RIDGWAY PLANNING COMMISSION

AGENDA

Tuesday, September 25th, 2018
Regular Meeting; 5:30 pm
Ridgway Community Center
201 North Railroad Street, Ridgway, Colorado

Subject: Preliminary Plat Submittal
Legal: Ridgway Land Company Subdivision Lots 30-34
Address: TBD Redcliff Drive
Parcel #s: 430516402012, 430516402011, 430516402010, 430516402009, 430516402008
Zone: General Commercial
Applicant: Joseph Nelson
Owners: Ridgway Land Co. / Rob Hunter
Initiated By: Shay Coburn, Planner
Date: September 25, 2018

Vista Park Commons - P.U.D.
Replat of Lots 30-34, Ridgway Land Company Subdivision
Located in the South 1/2 of the North 1/2, Section 16, Township 45 North, Range 8 West, NMPM,
Town of Ridgway, County of Ouray, State of Colorado

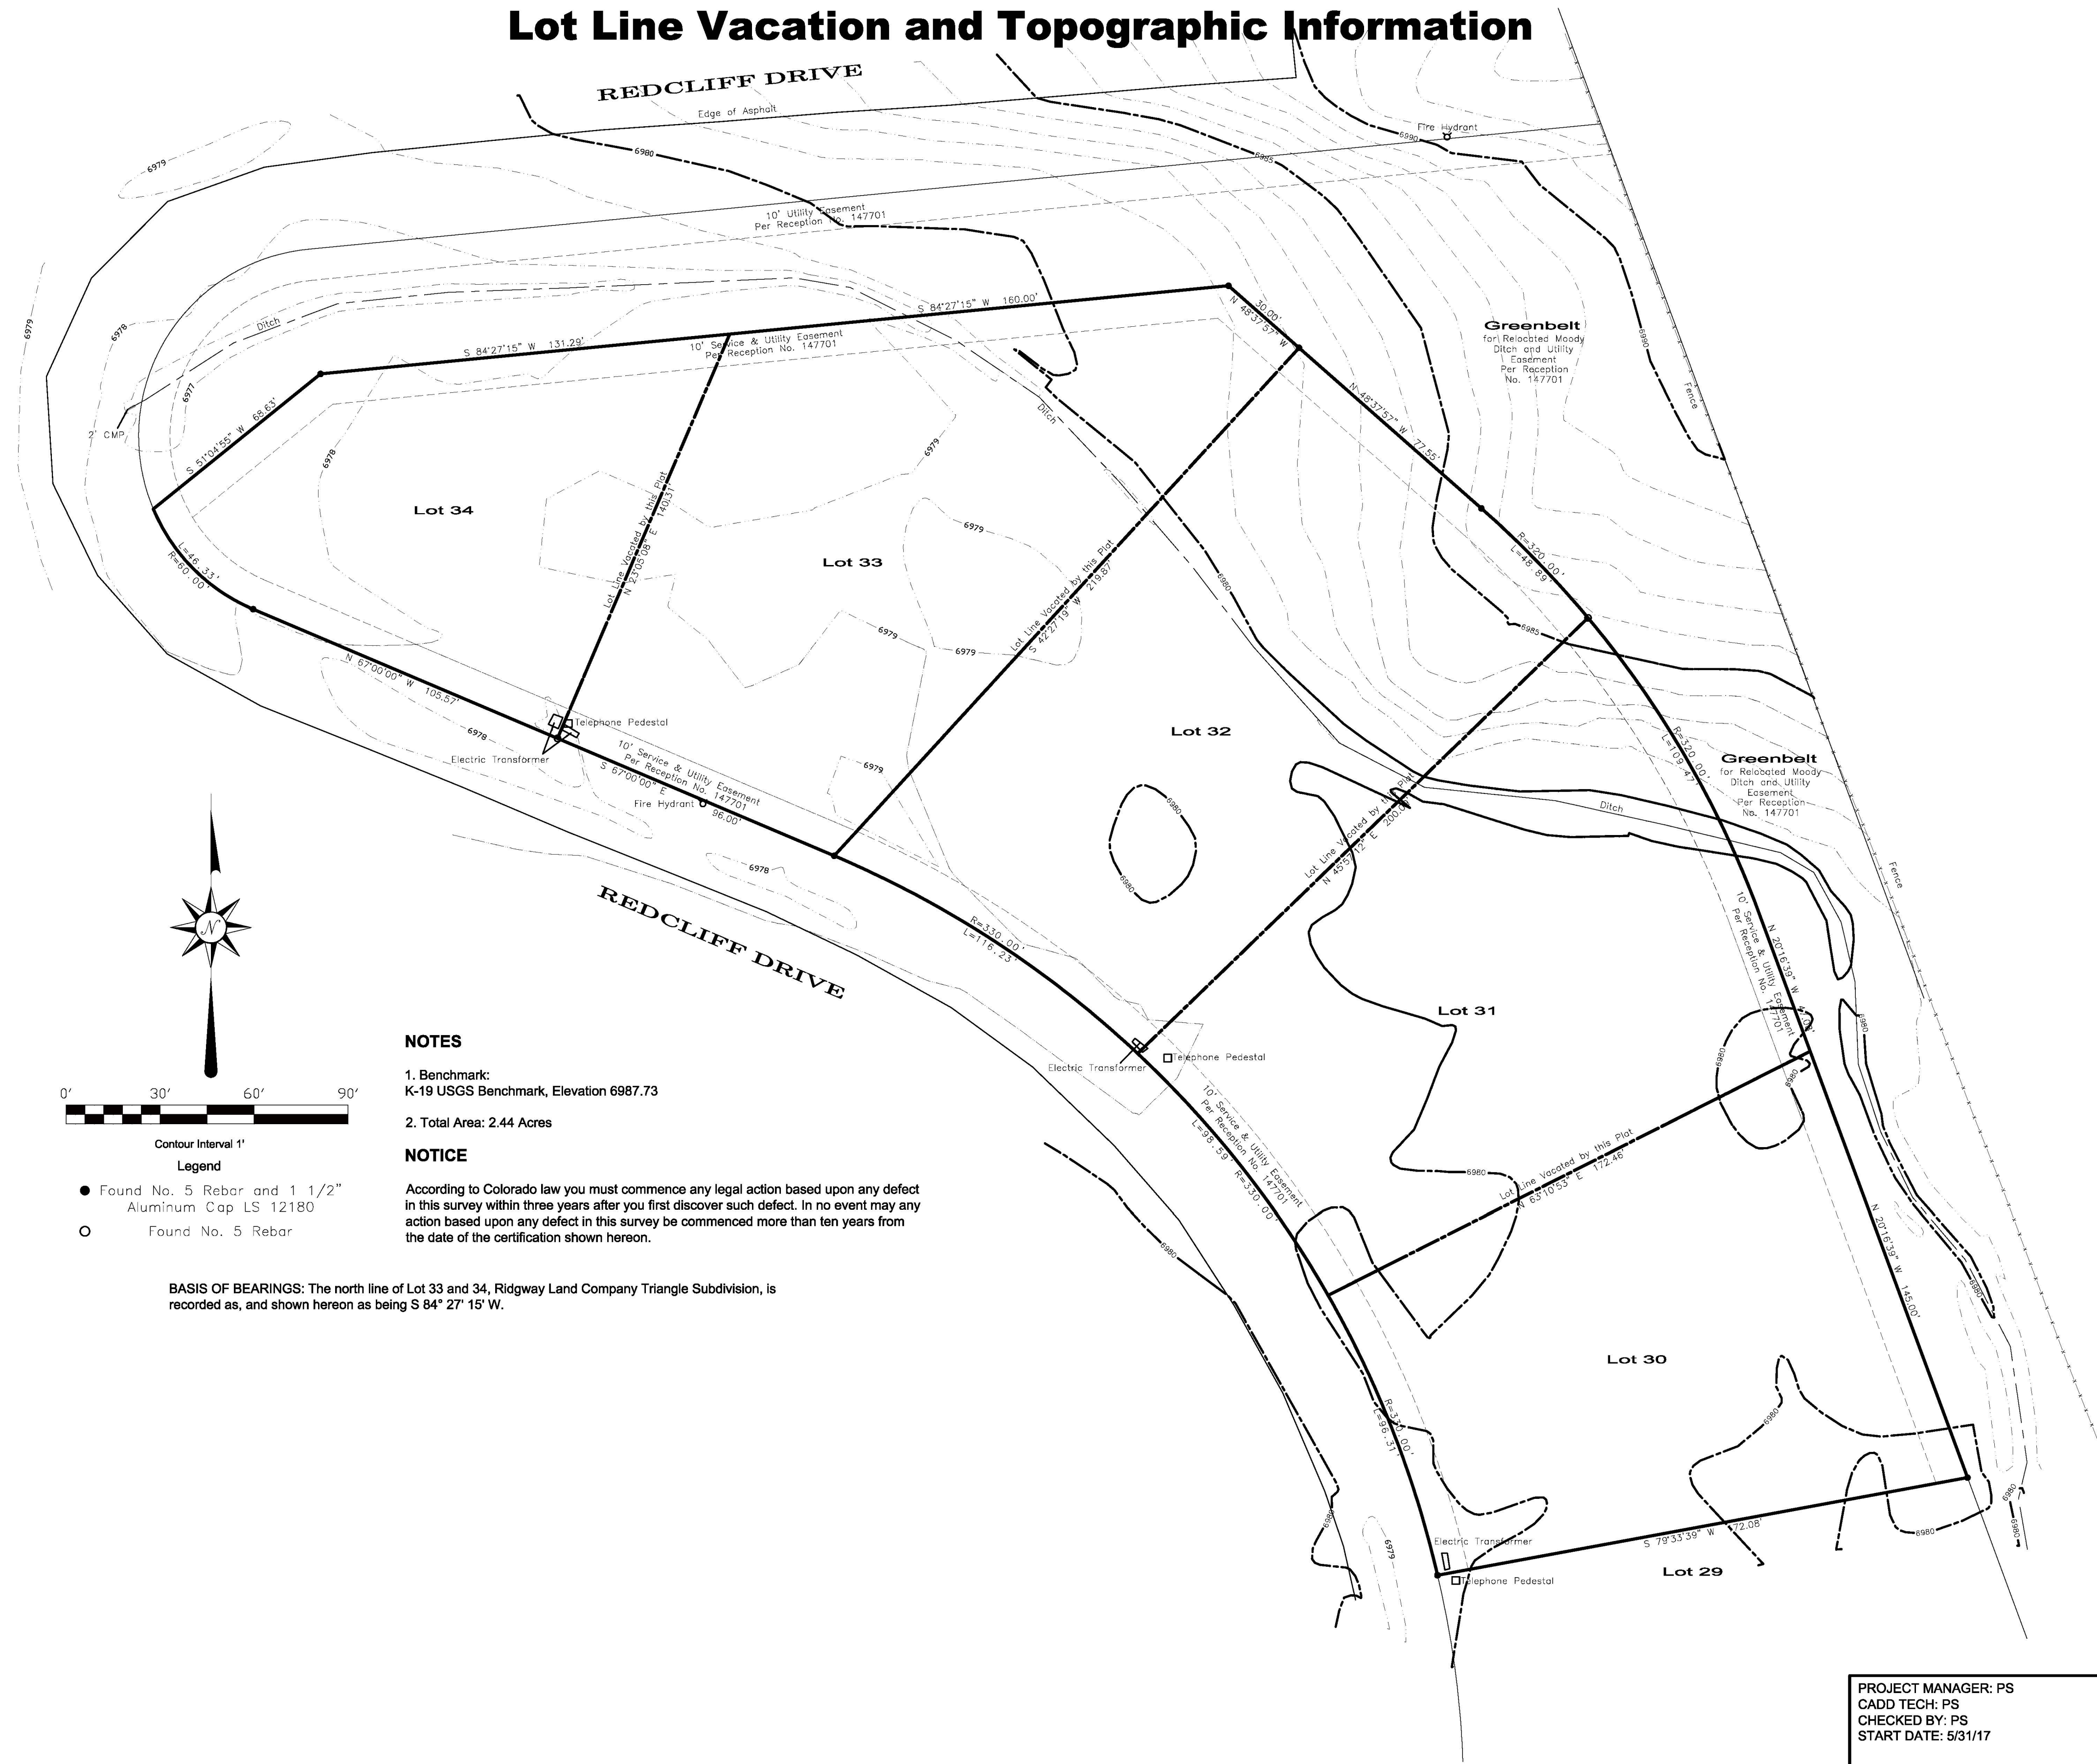
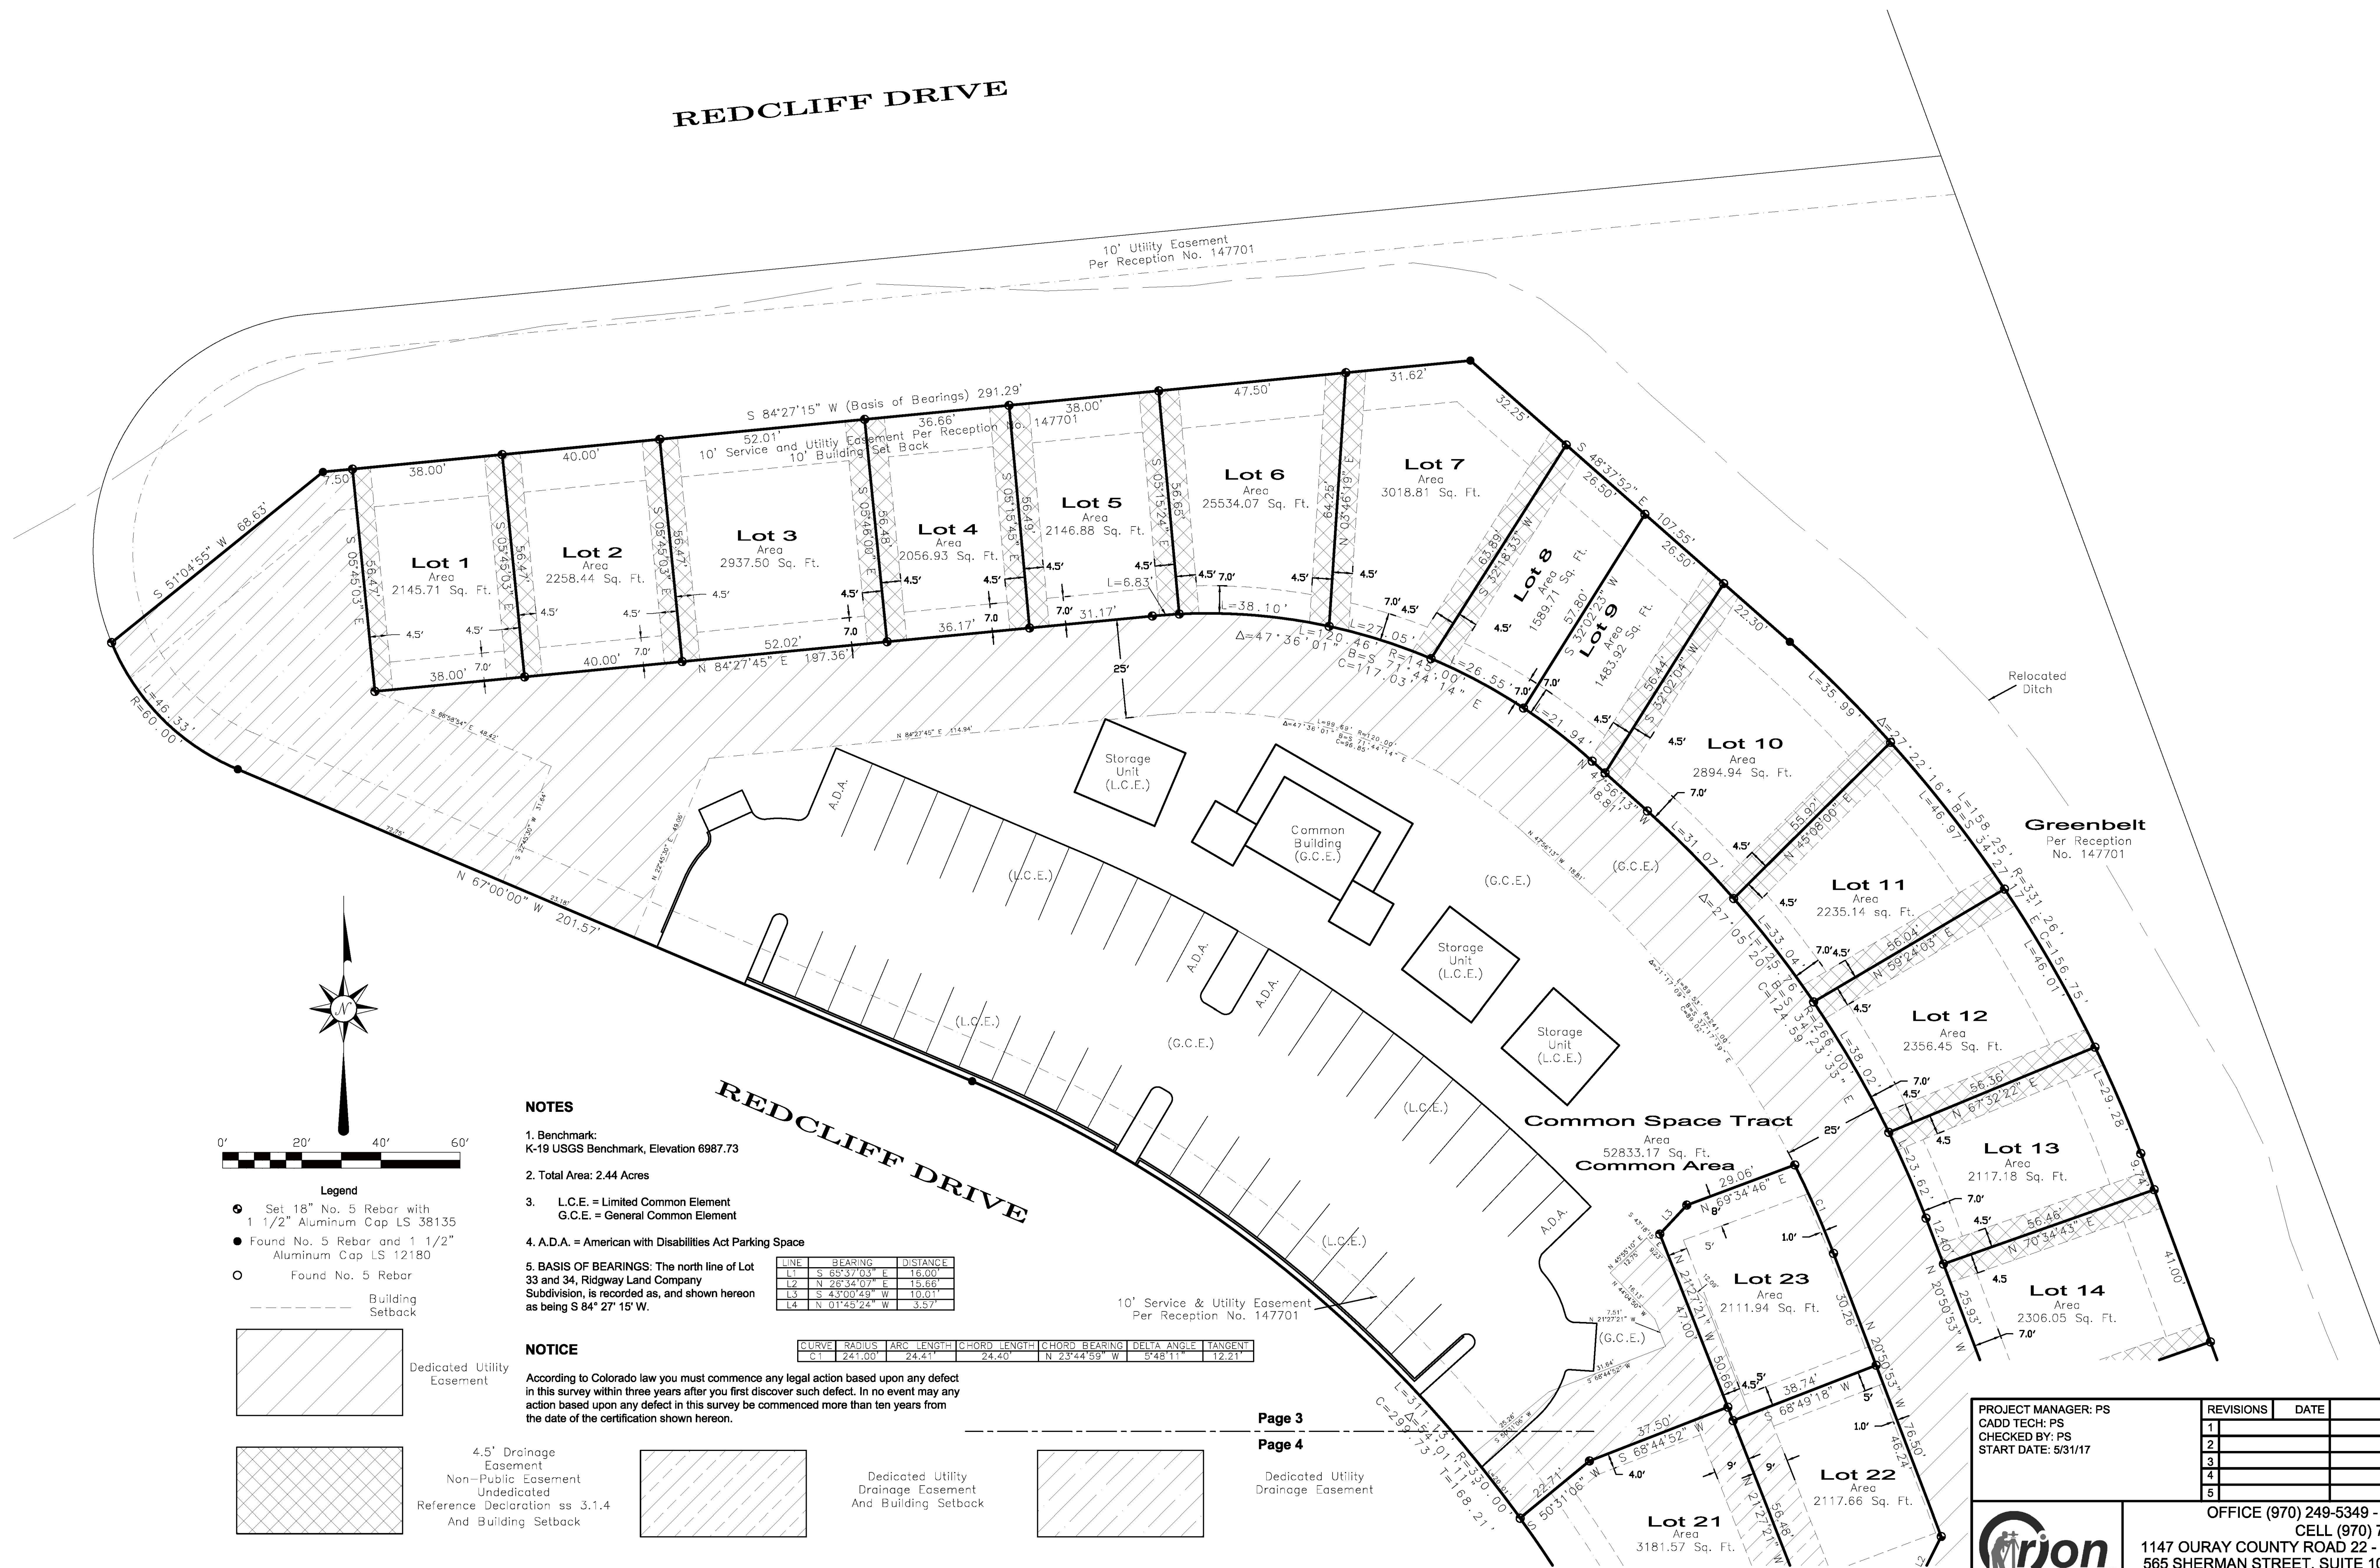
- The plat map is missing a stamp from the surveyor. *Will need a stamp once the plans are approved by the Planning Commission and/or Town Council.*
- The basis of bearing on the plat map needs to be labeled on page 2. All basis of bearing text should reference the “Ridgway Land Company Subdivision” not the “Ridgway Land Company Triangle Subdivision.” *Page 2 still needs to be corrected.*

- Page 4 is missing the drainage easement on the top of the map. Add or combine pages as suggested above. [Complete.](#)
- Declarations should only be referenced once where the recording number will be filled in. See notes 2 and 9 for examples where reference should be removed. This constant cross references will cause confusion in the future when the declarations are edited, likely bringing up the need for a plat amendment. Reference the plat map as an exhibit to the declarations. [Applicant stated: The reason for the cross reference is that the rights and privileges to the LCE are subject to further refinement in the Declarations. Without this, the rights and privileges to the LCE per the Plat appear unrestricted, and they are not. See Art 4 of Decs. The same is true with respect to maintenance of the LCE and GCE in the there are many refinements to the maintenance obligations as between the HOA and the Unit Owners. Without this reference, the Plat appears make this the sole obligation of the HOA. See Art 7 of the Decs. My understanding is that both the Plat and the Decs are to be approved by the Town Council, and any future change in either document will require the same amendment procedure. Town response: The decs are reviewed by the Town to be sure they do not involve the Town and to avoid any foreseen issues. The Town does not review any future changes to the decs unless required by the decs, which is not a good idea. Things that Town enforces should be on the plat, things that the HOA enforces shouldn't be on the plat, just reference the declaration and the reception number. All other cross references shall be removed as asked for above. If the applicant wants, they can add language to reference of the private declarations like – “Notice for all potential buyers and owners: you are advised to read the private declarations in their entirety”. Any cross references to the decs in the dedication language also needs to be removed. If an easement is dedicated to the town, we don't want to find further restrictions or allow the HOA to further restrict in the future through an amendment to the declarations.](#)

Need to show the location of the relocated ditch on pages 3 and 4 of the plat. Ensure it matches the civil plans. *While there are no dimensions, bearings, distances, etc. it appears to match and was added to the plat map.*

- Easement measurements between buildings are not consistent between the preliminary plat map and the other site plan provided, especially on the southern side of the property. Please reconcile. *U-1 and pages 3-4 on the plat still don't match – between lots 16, 17, 18, 19, 22, and 23. Why was a utility easement added to lot 23 just on page 4?*

Lots along Redcliff Drive appear to have two building setback lines. Use a different line type to depict easement boundaries. *If lines were changed, they are not different enough to tell (or just don't print well).* Also, please add the easement line type to the legend.
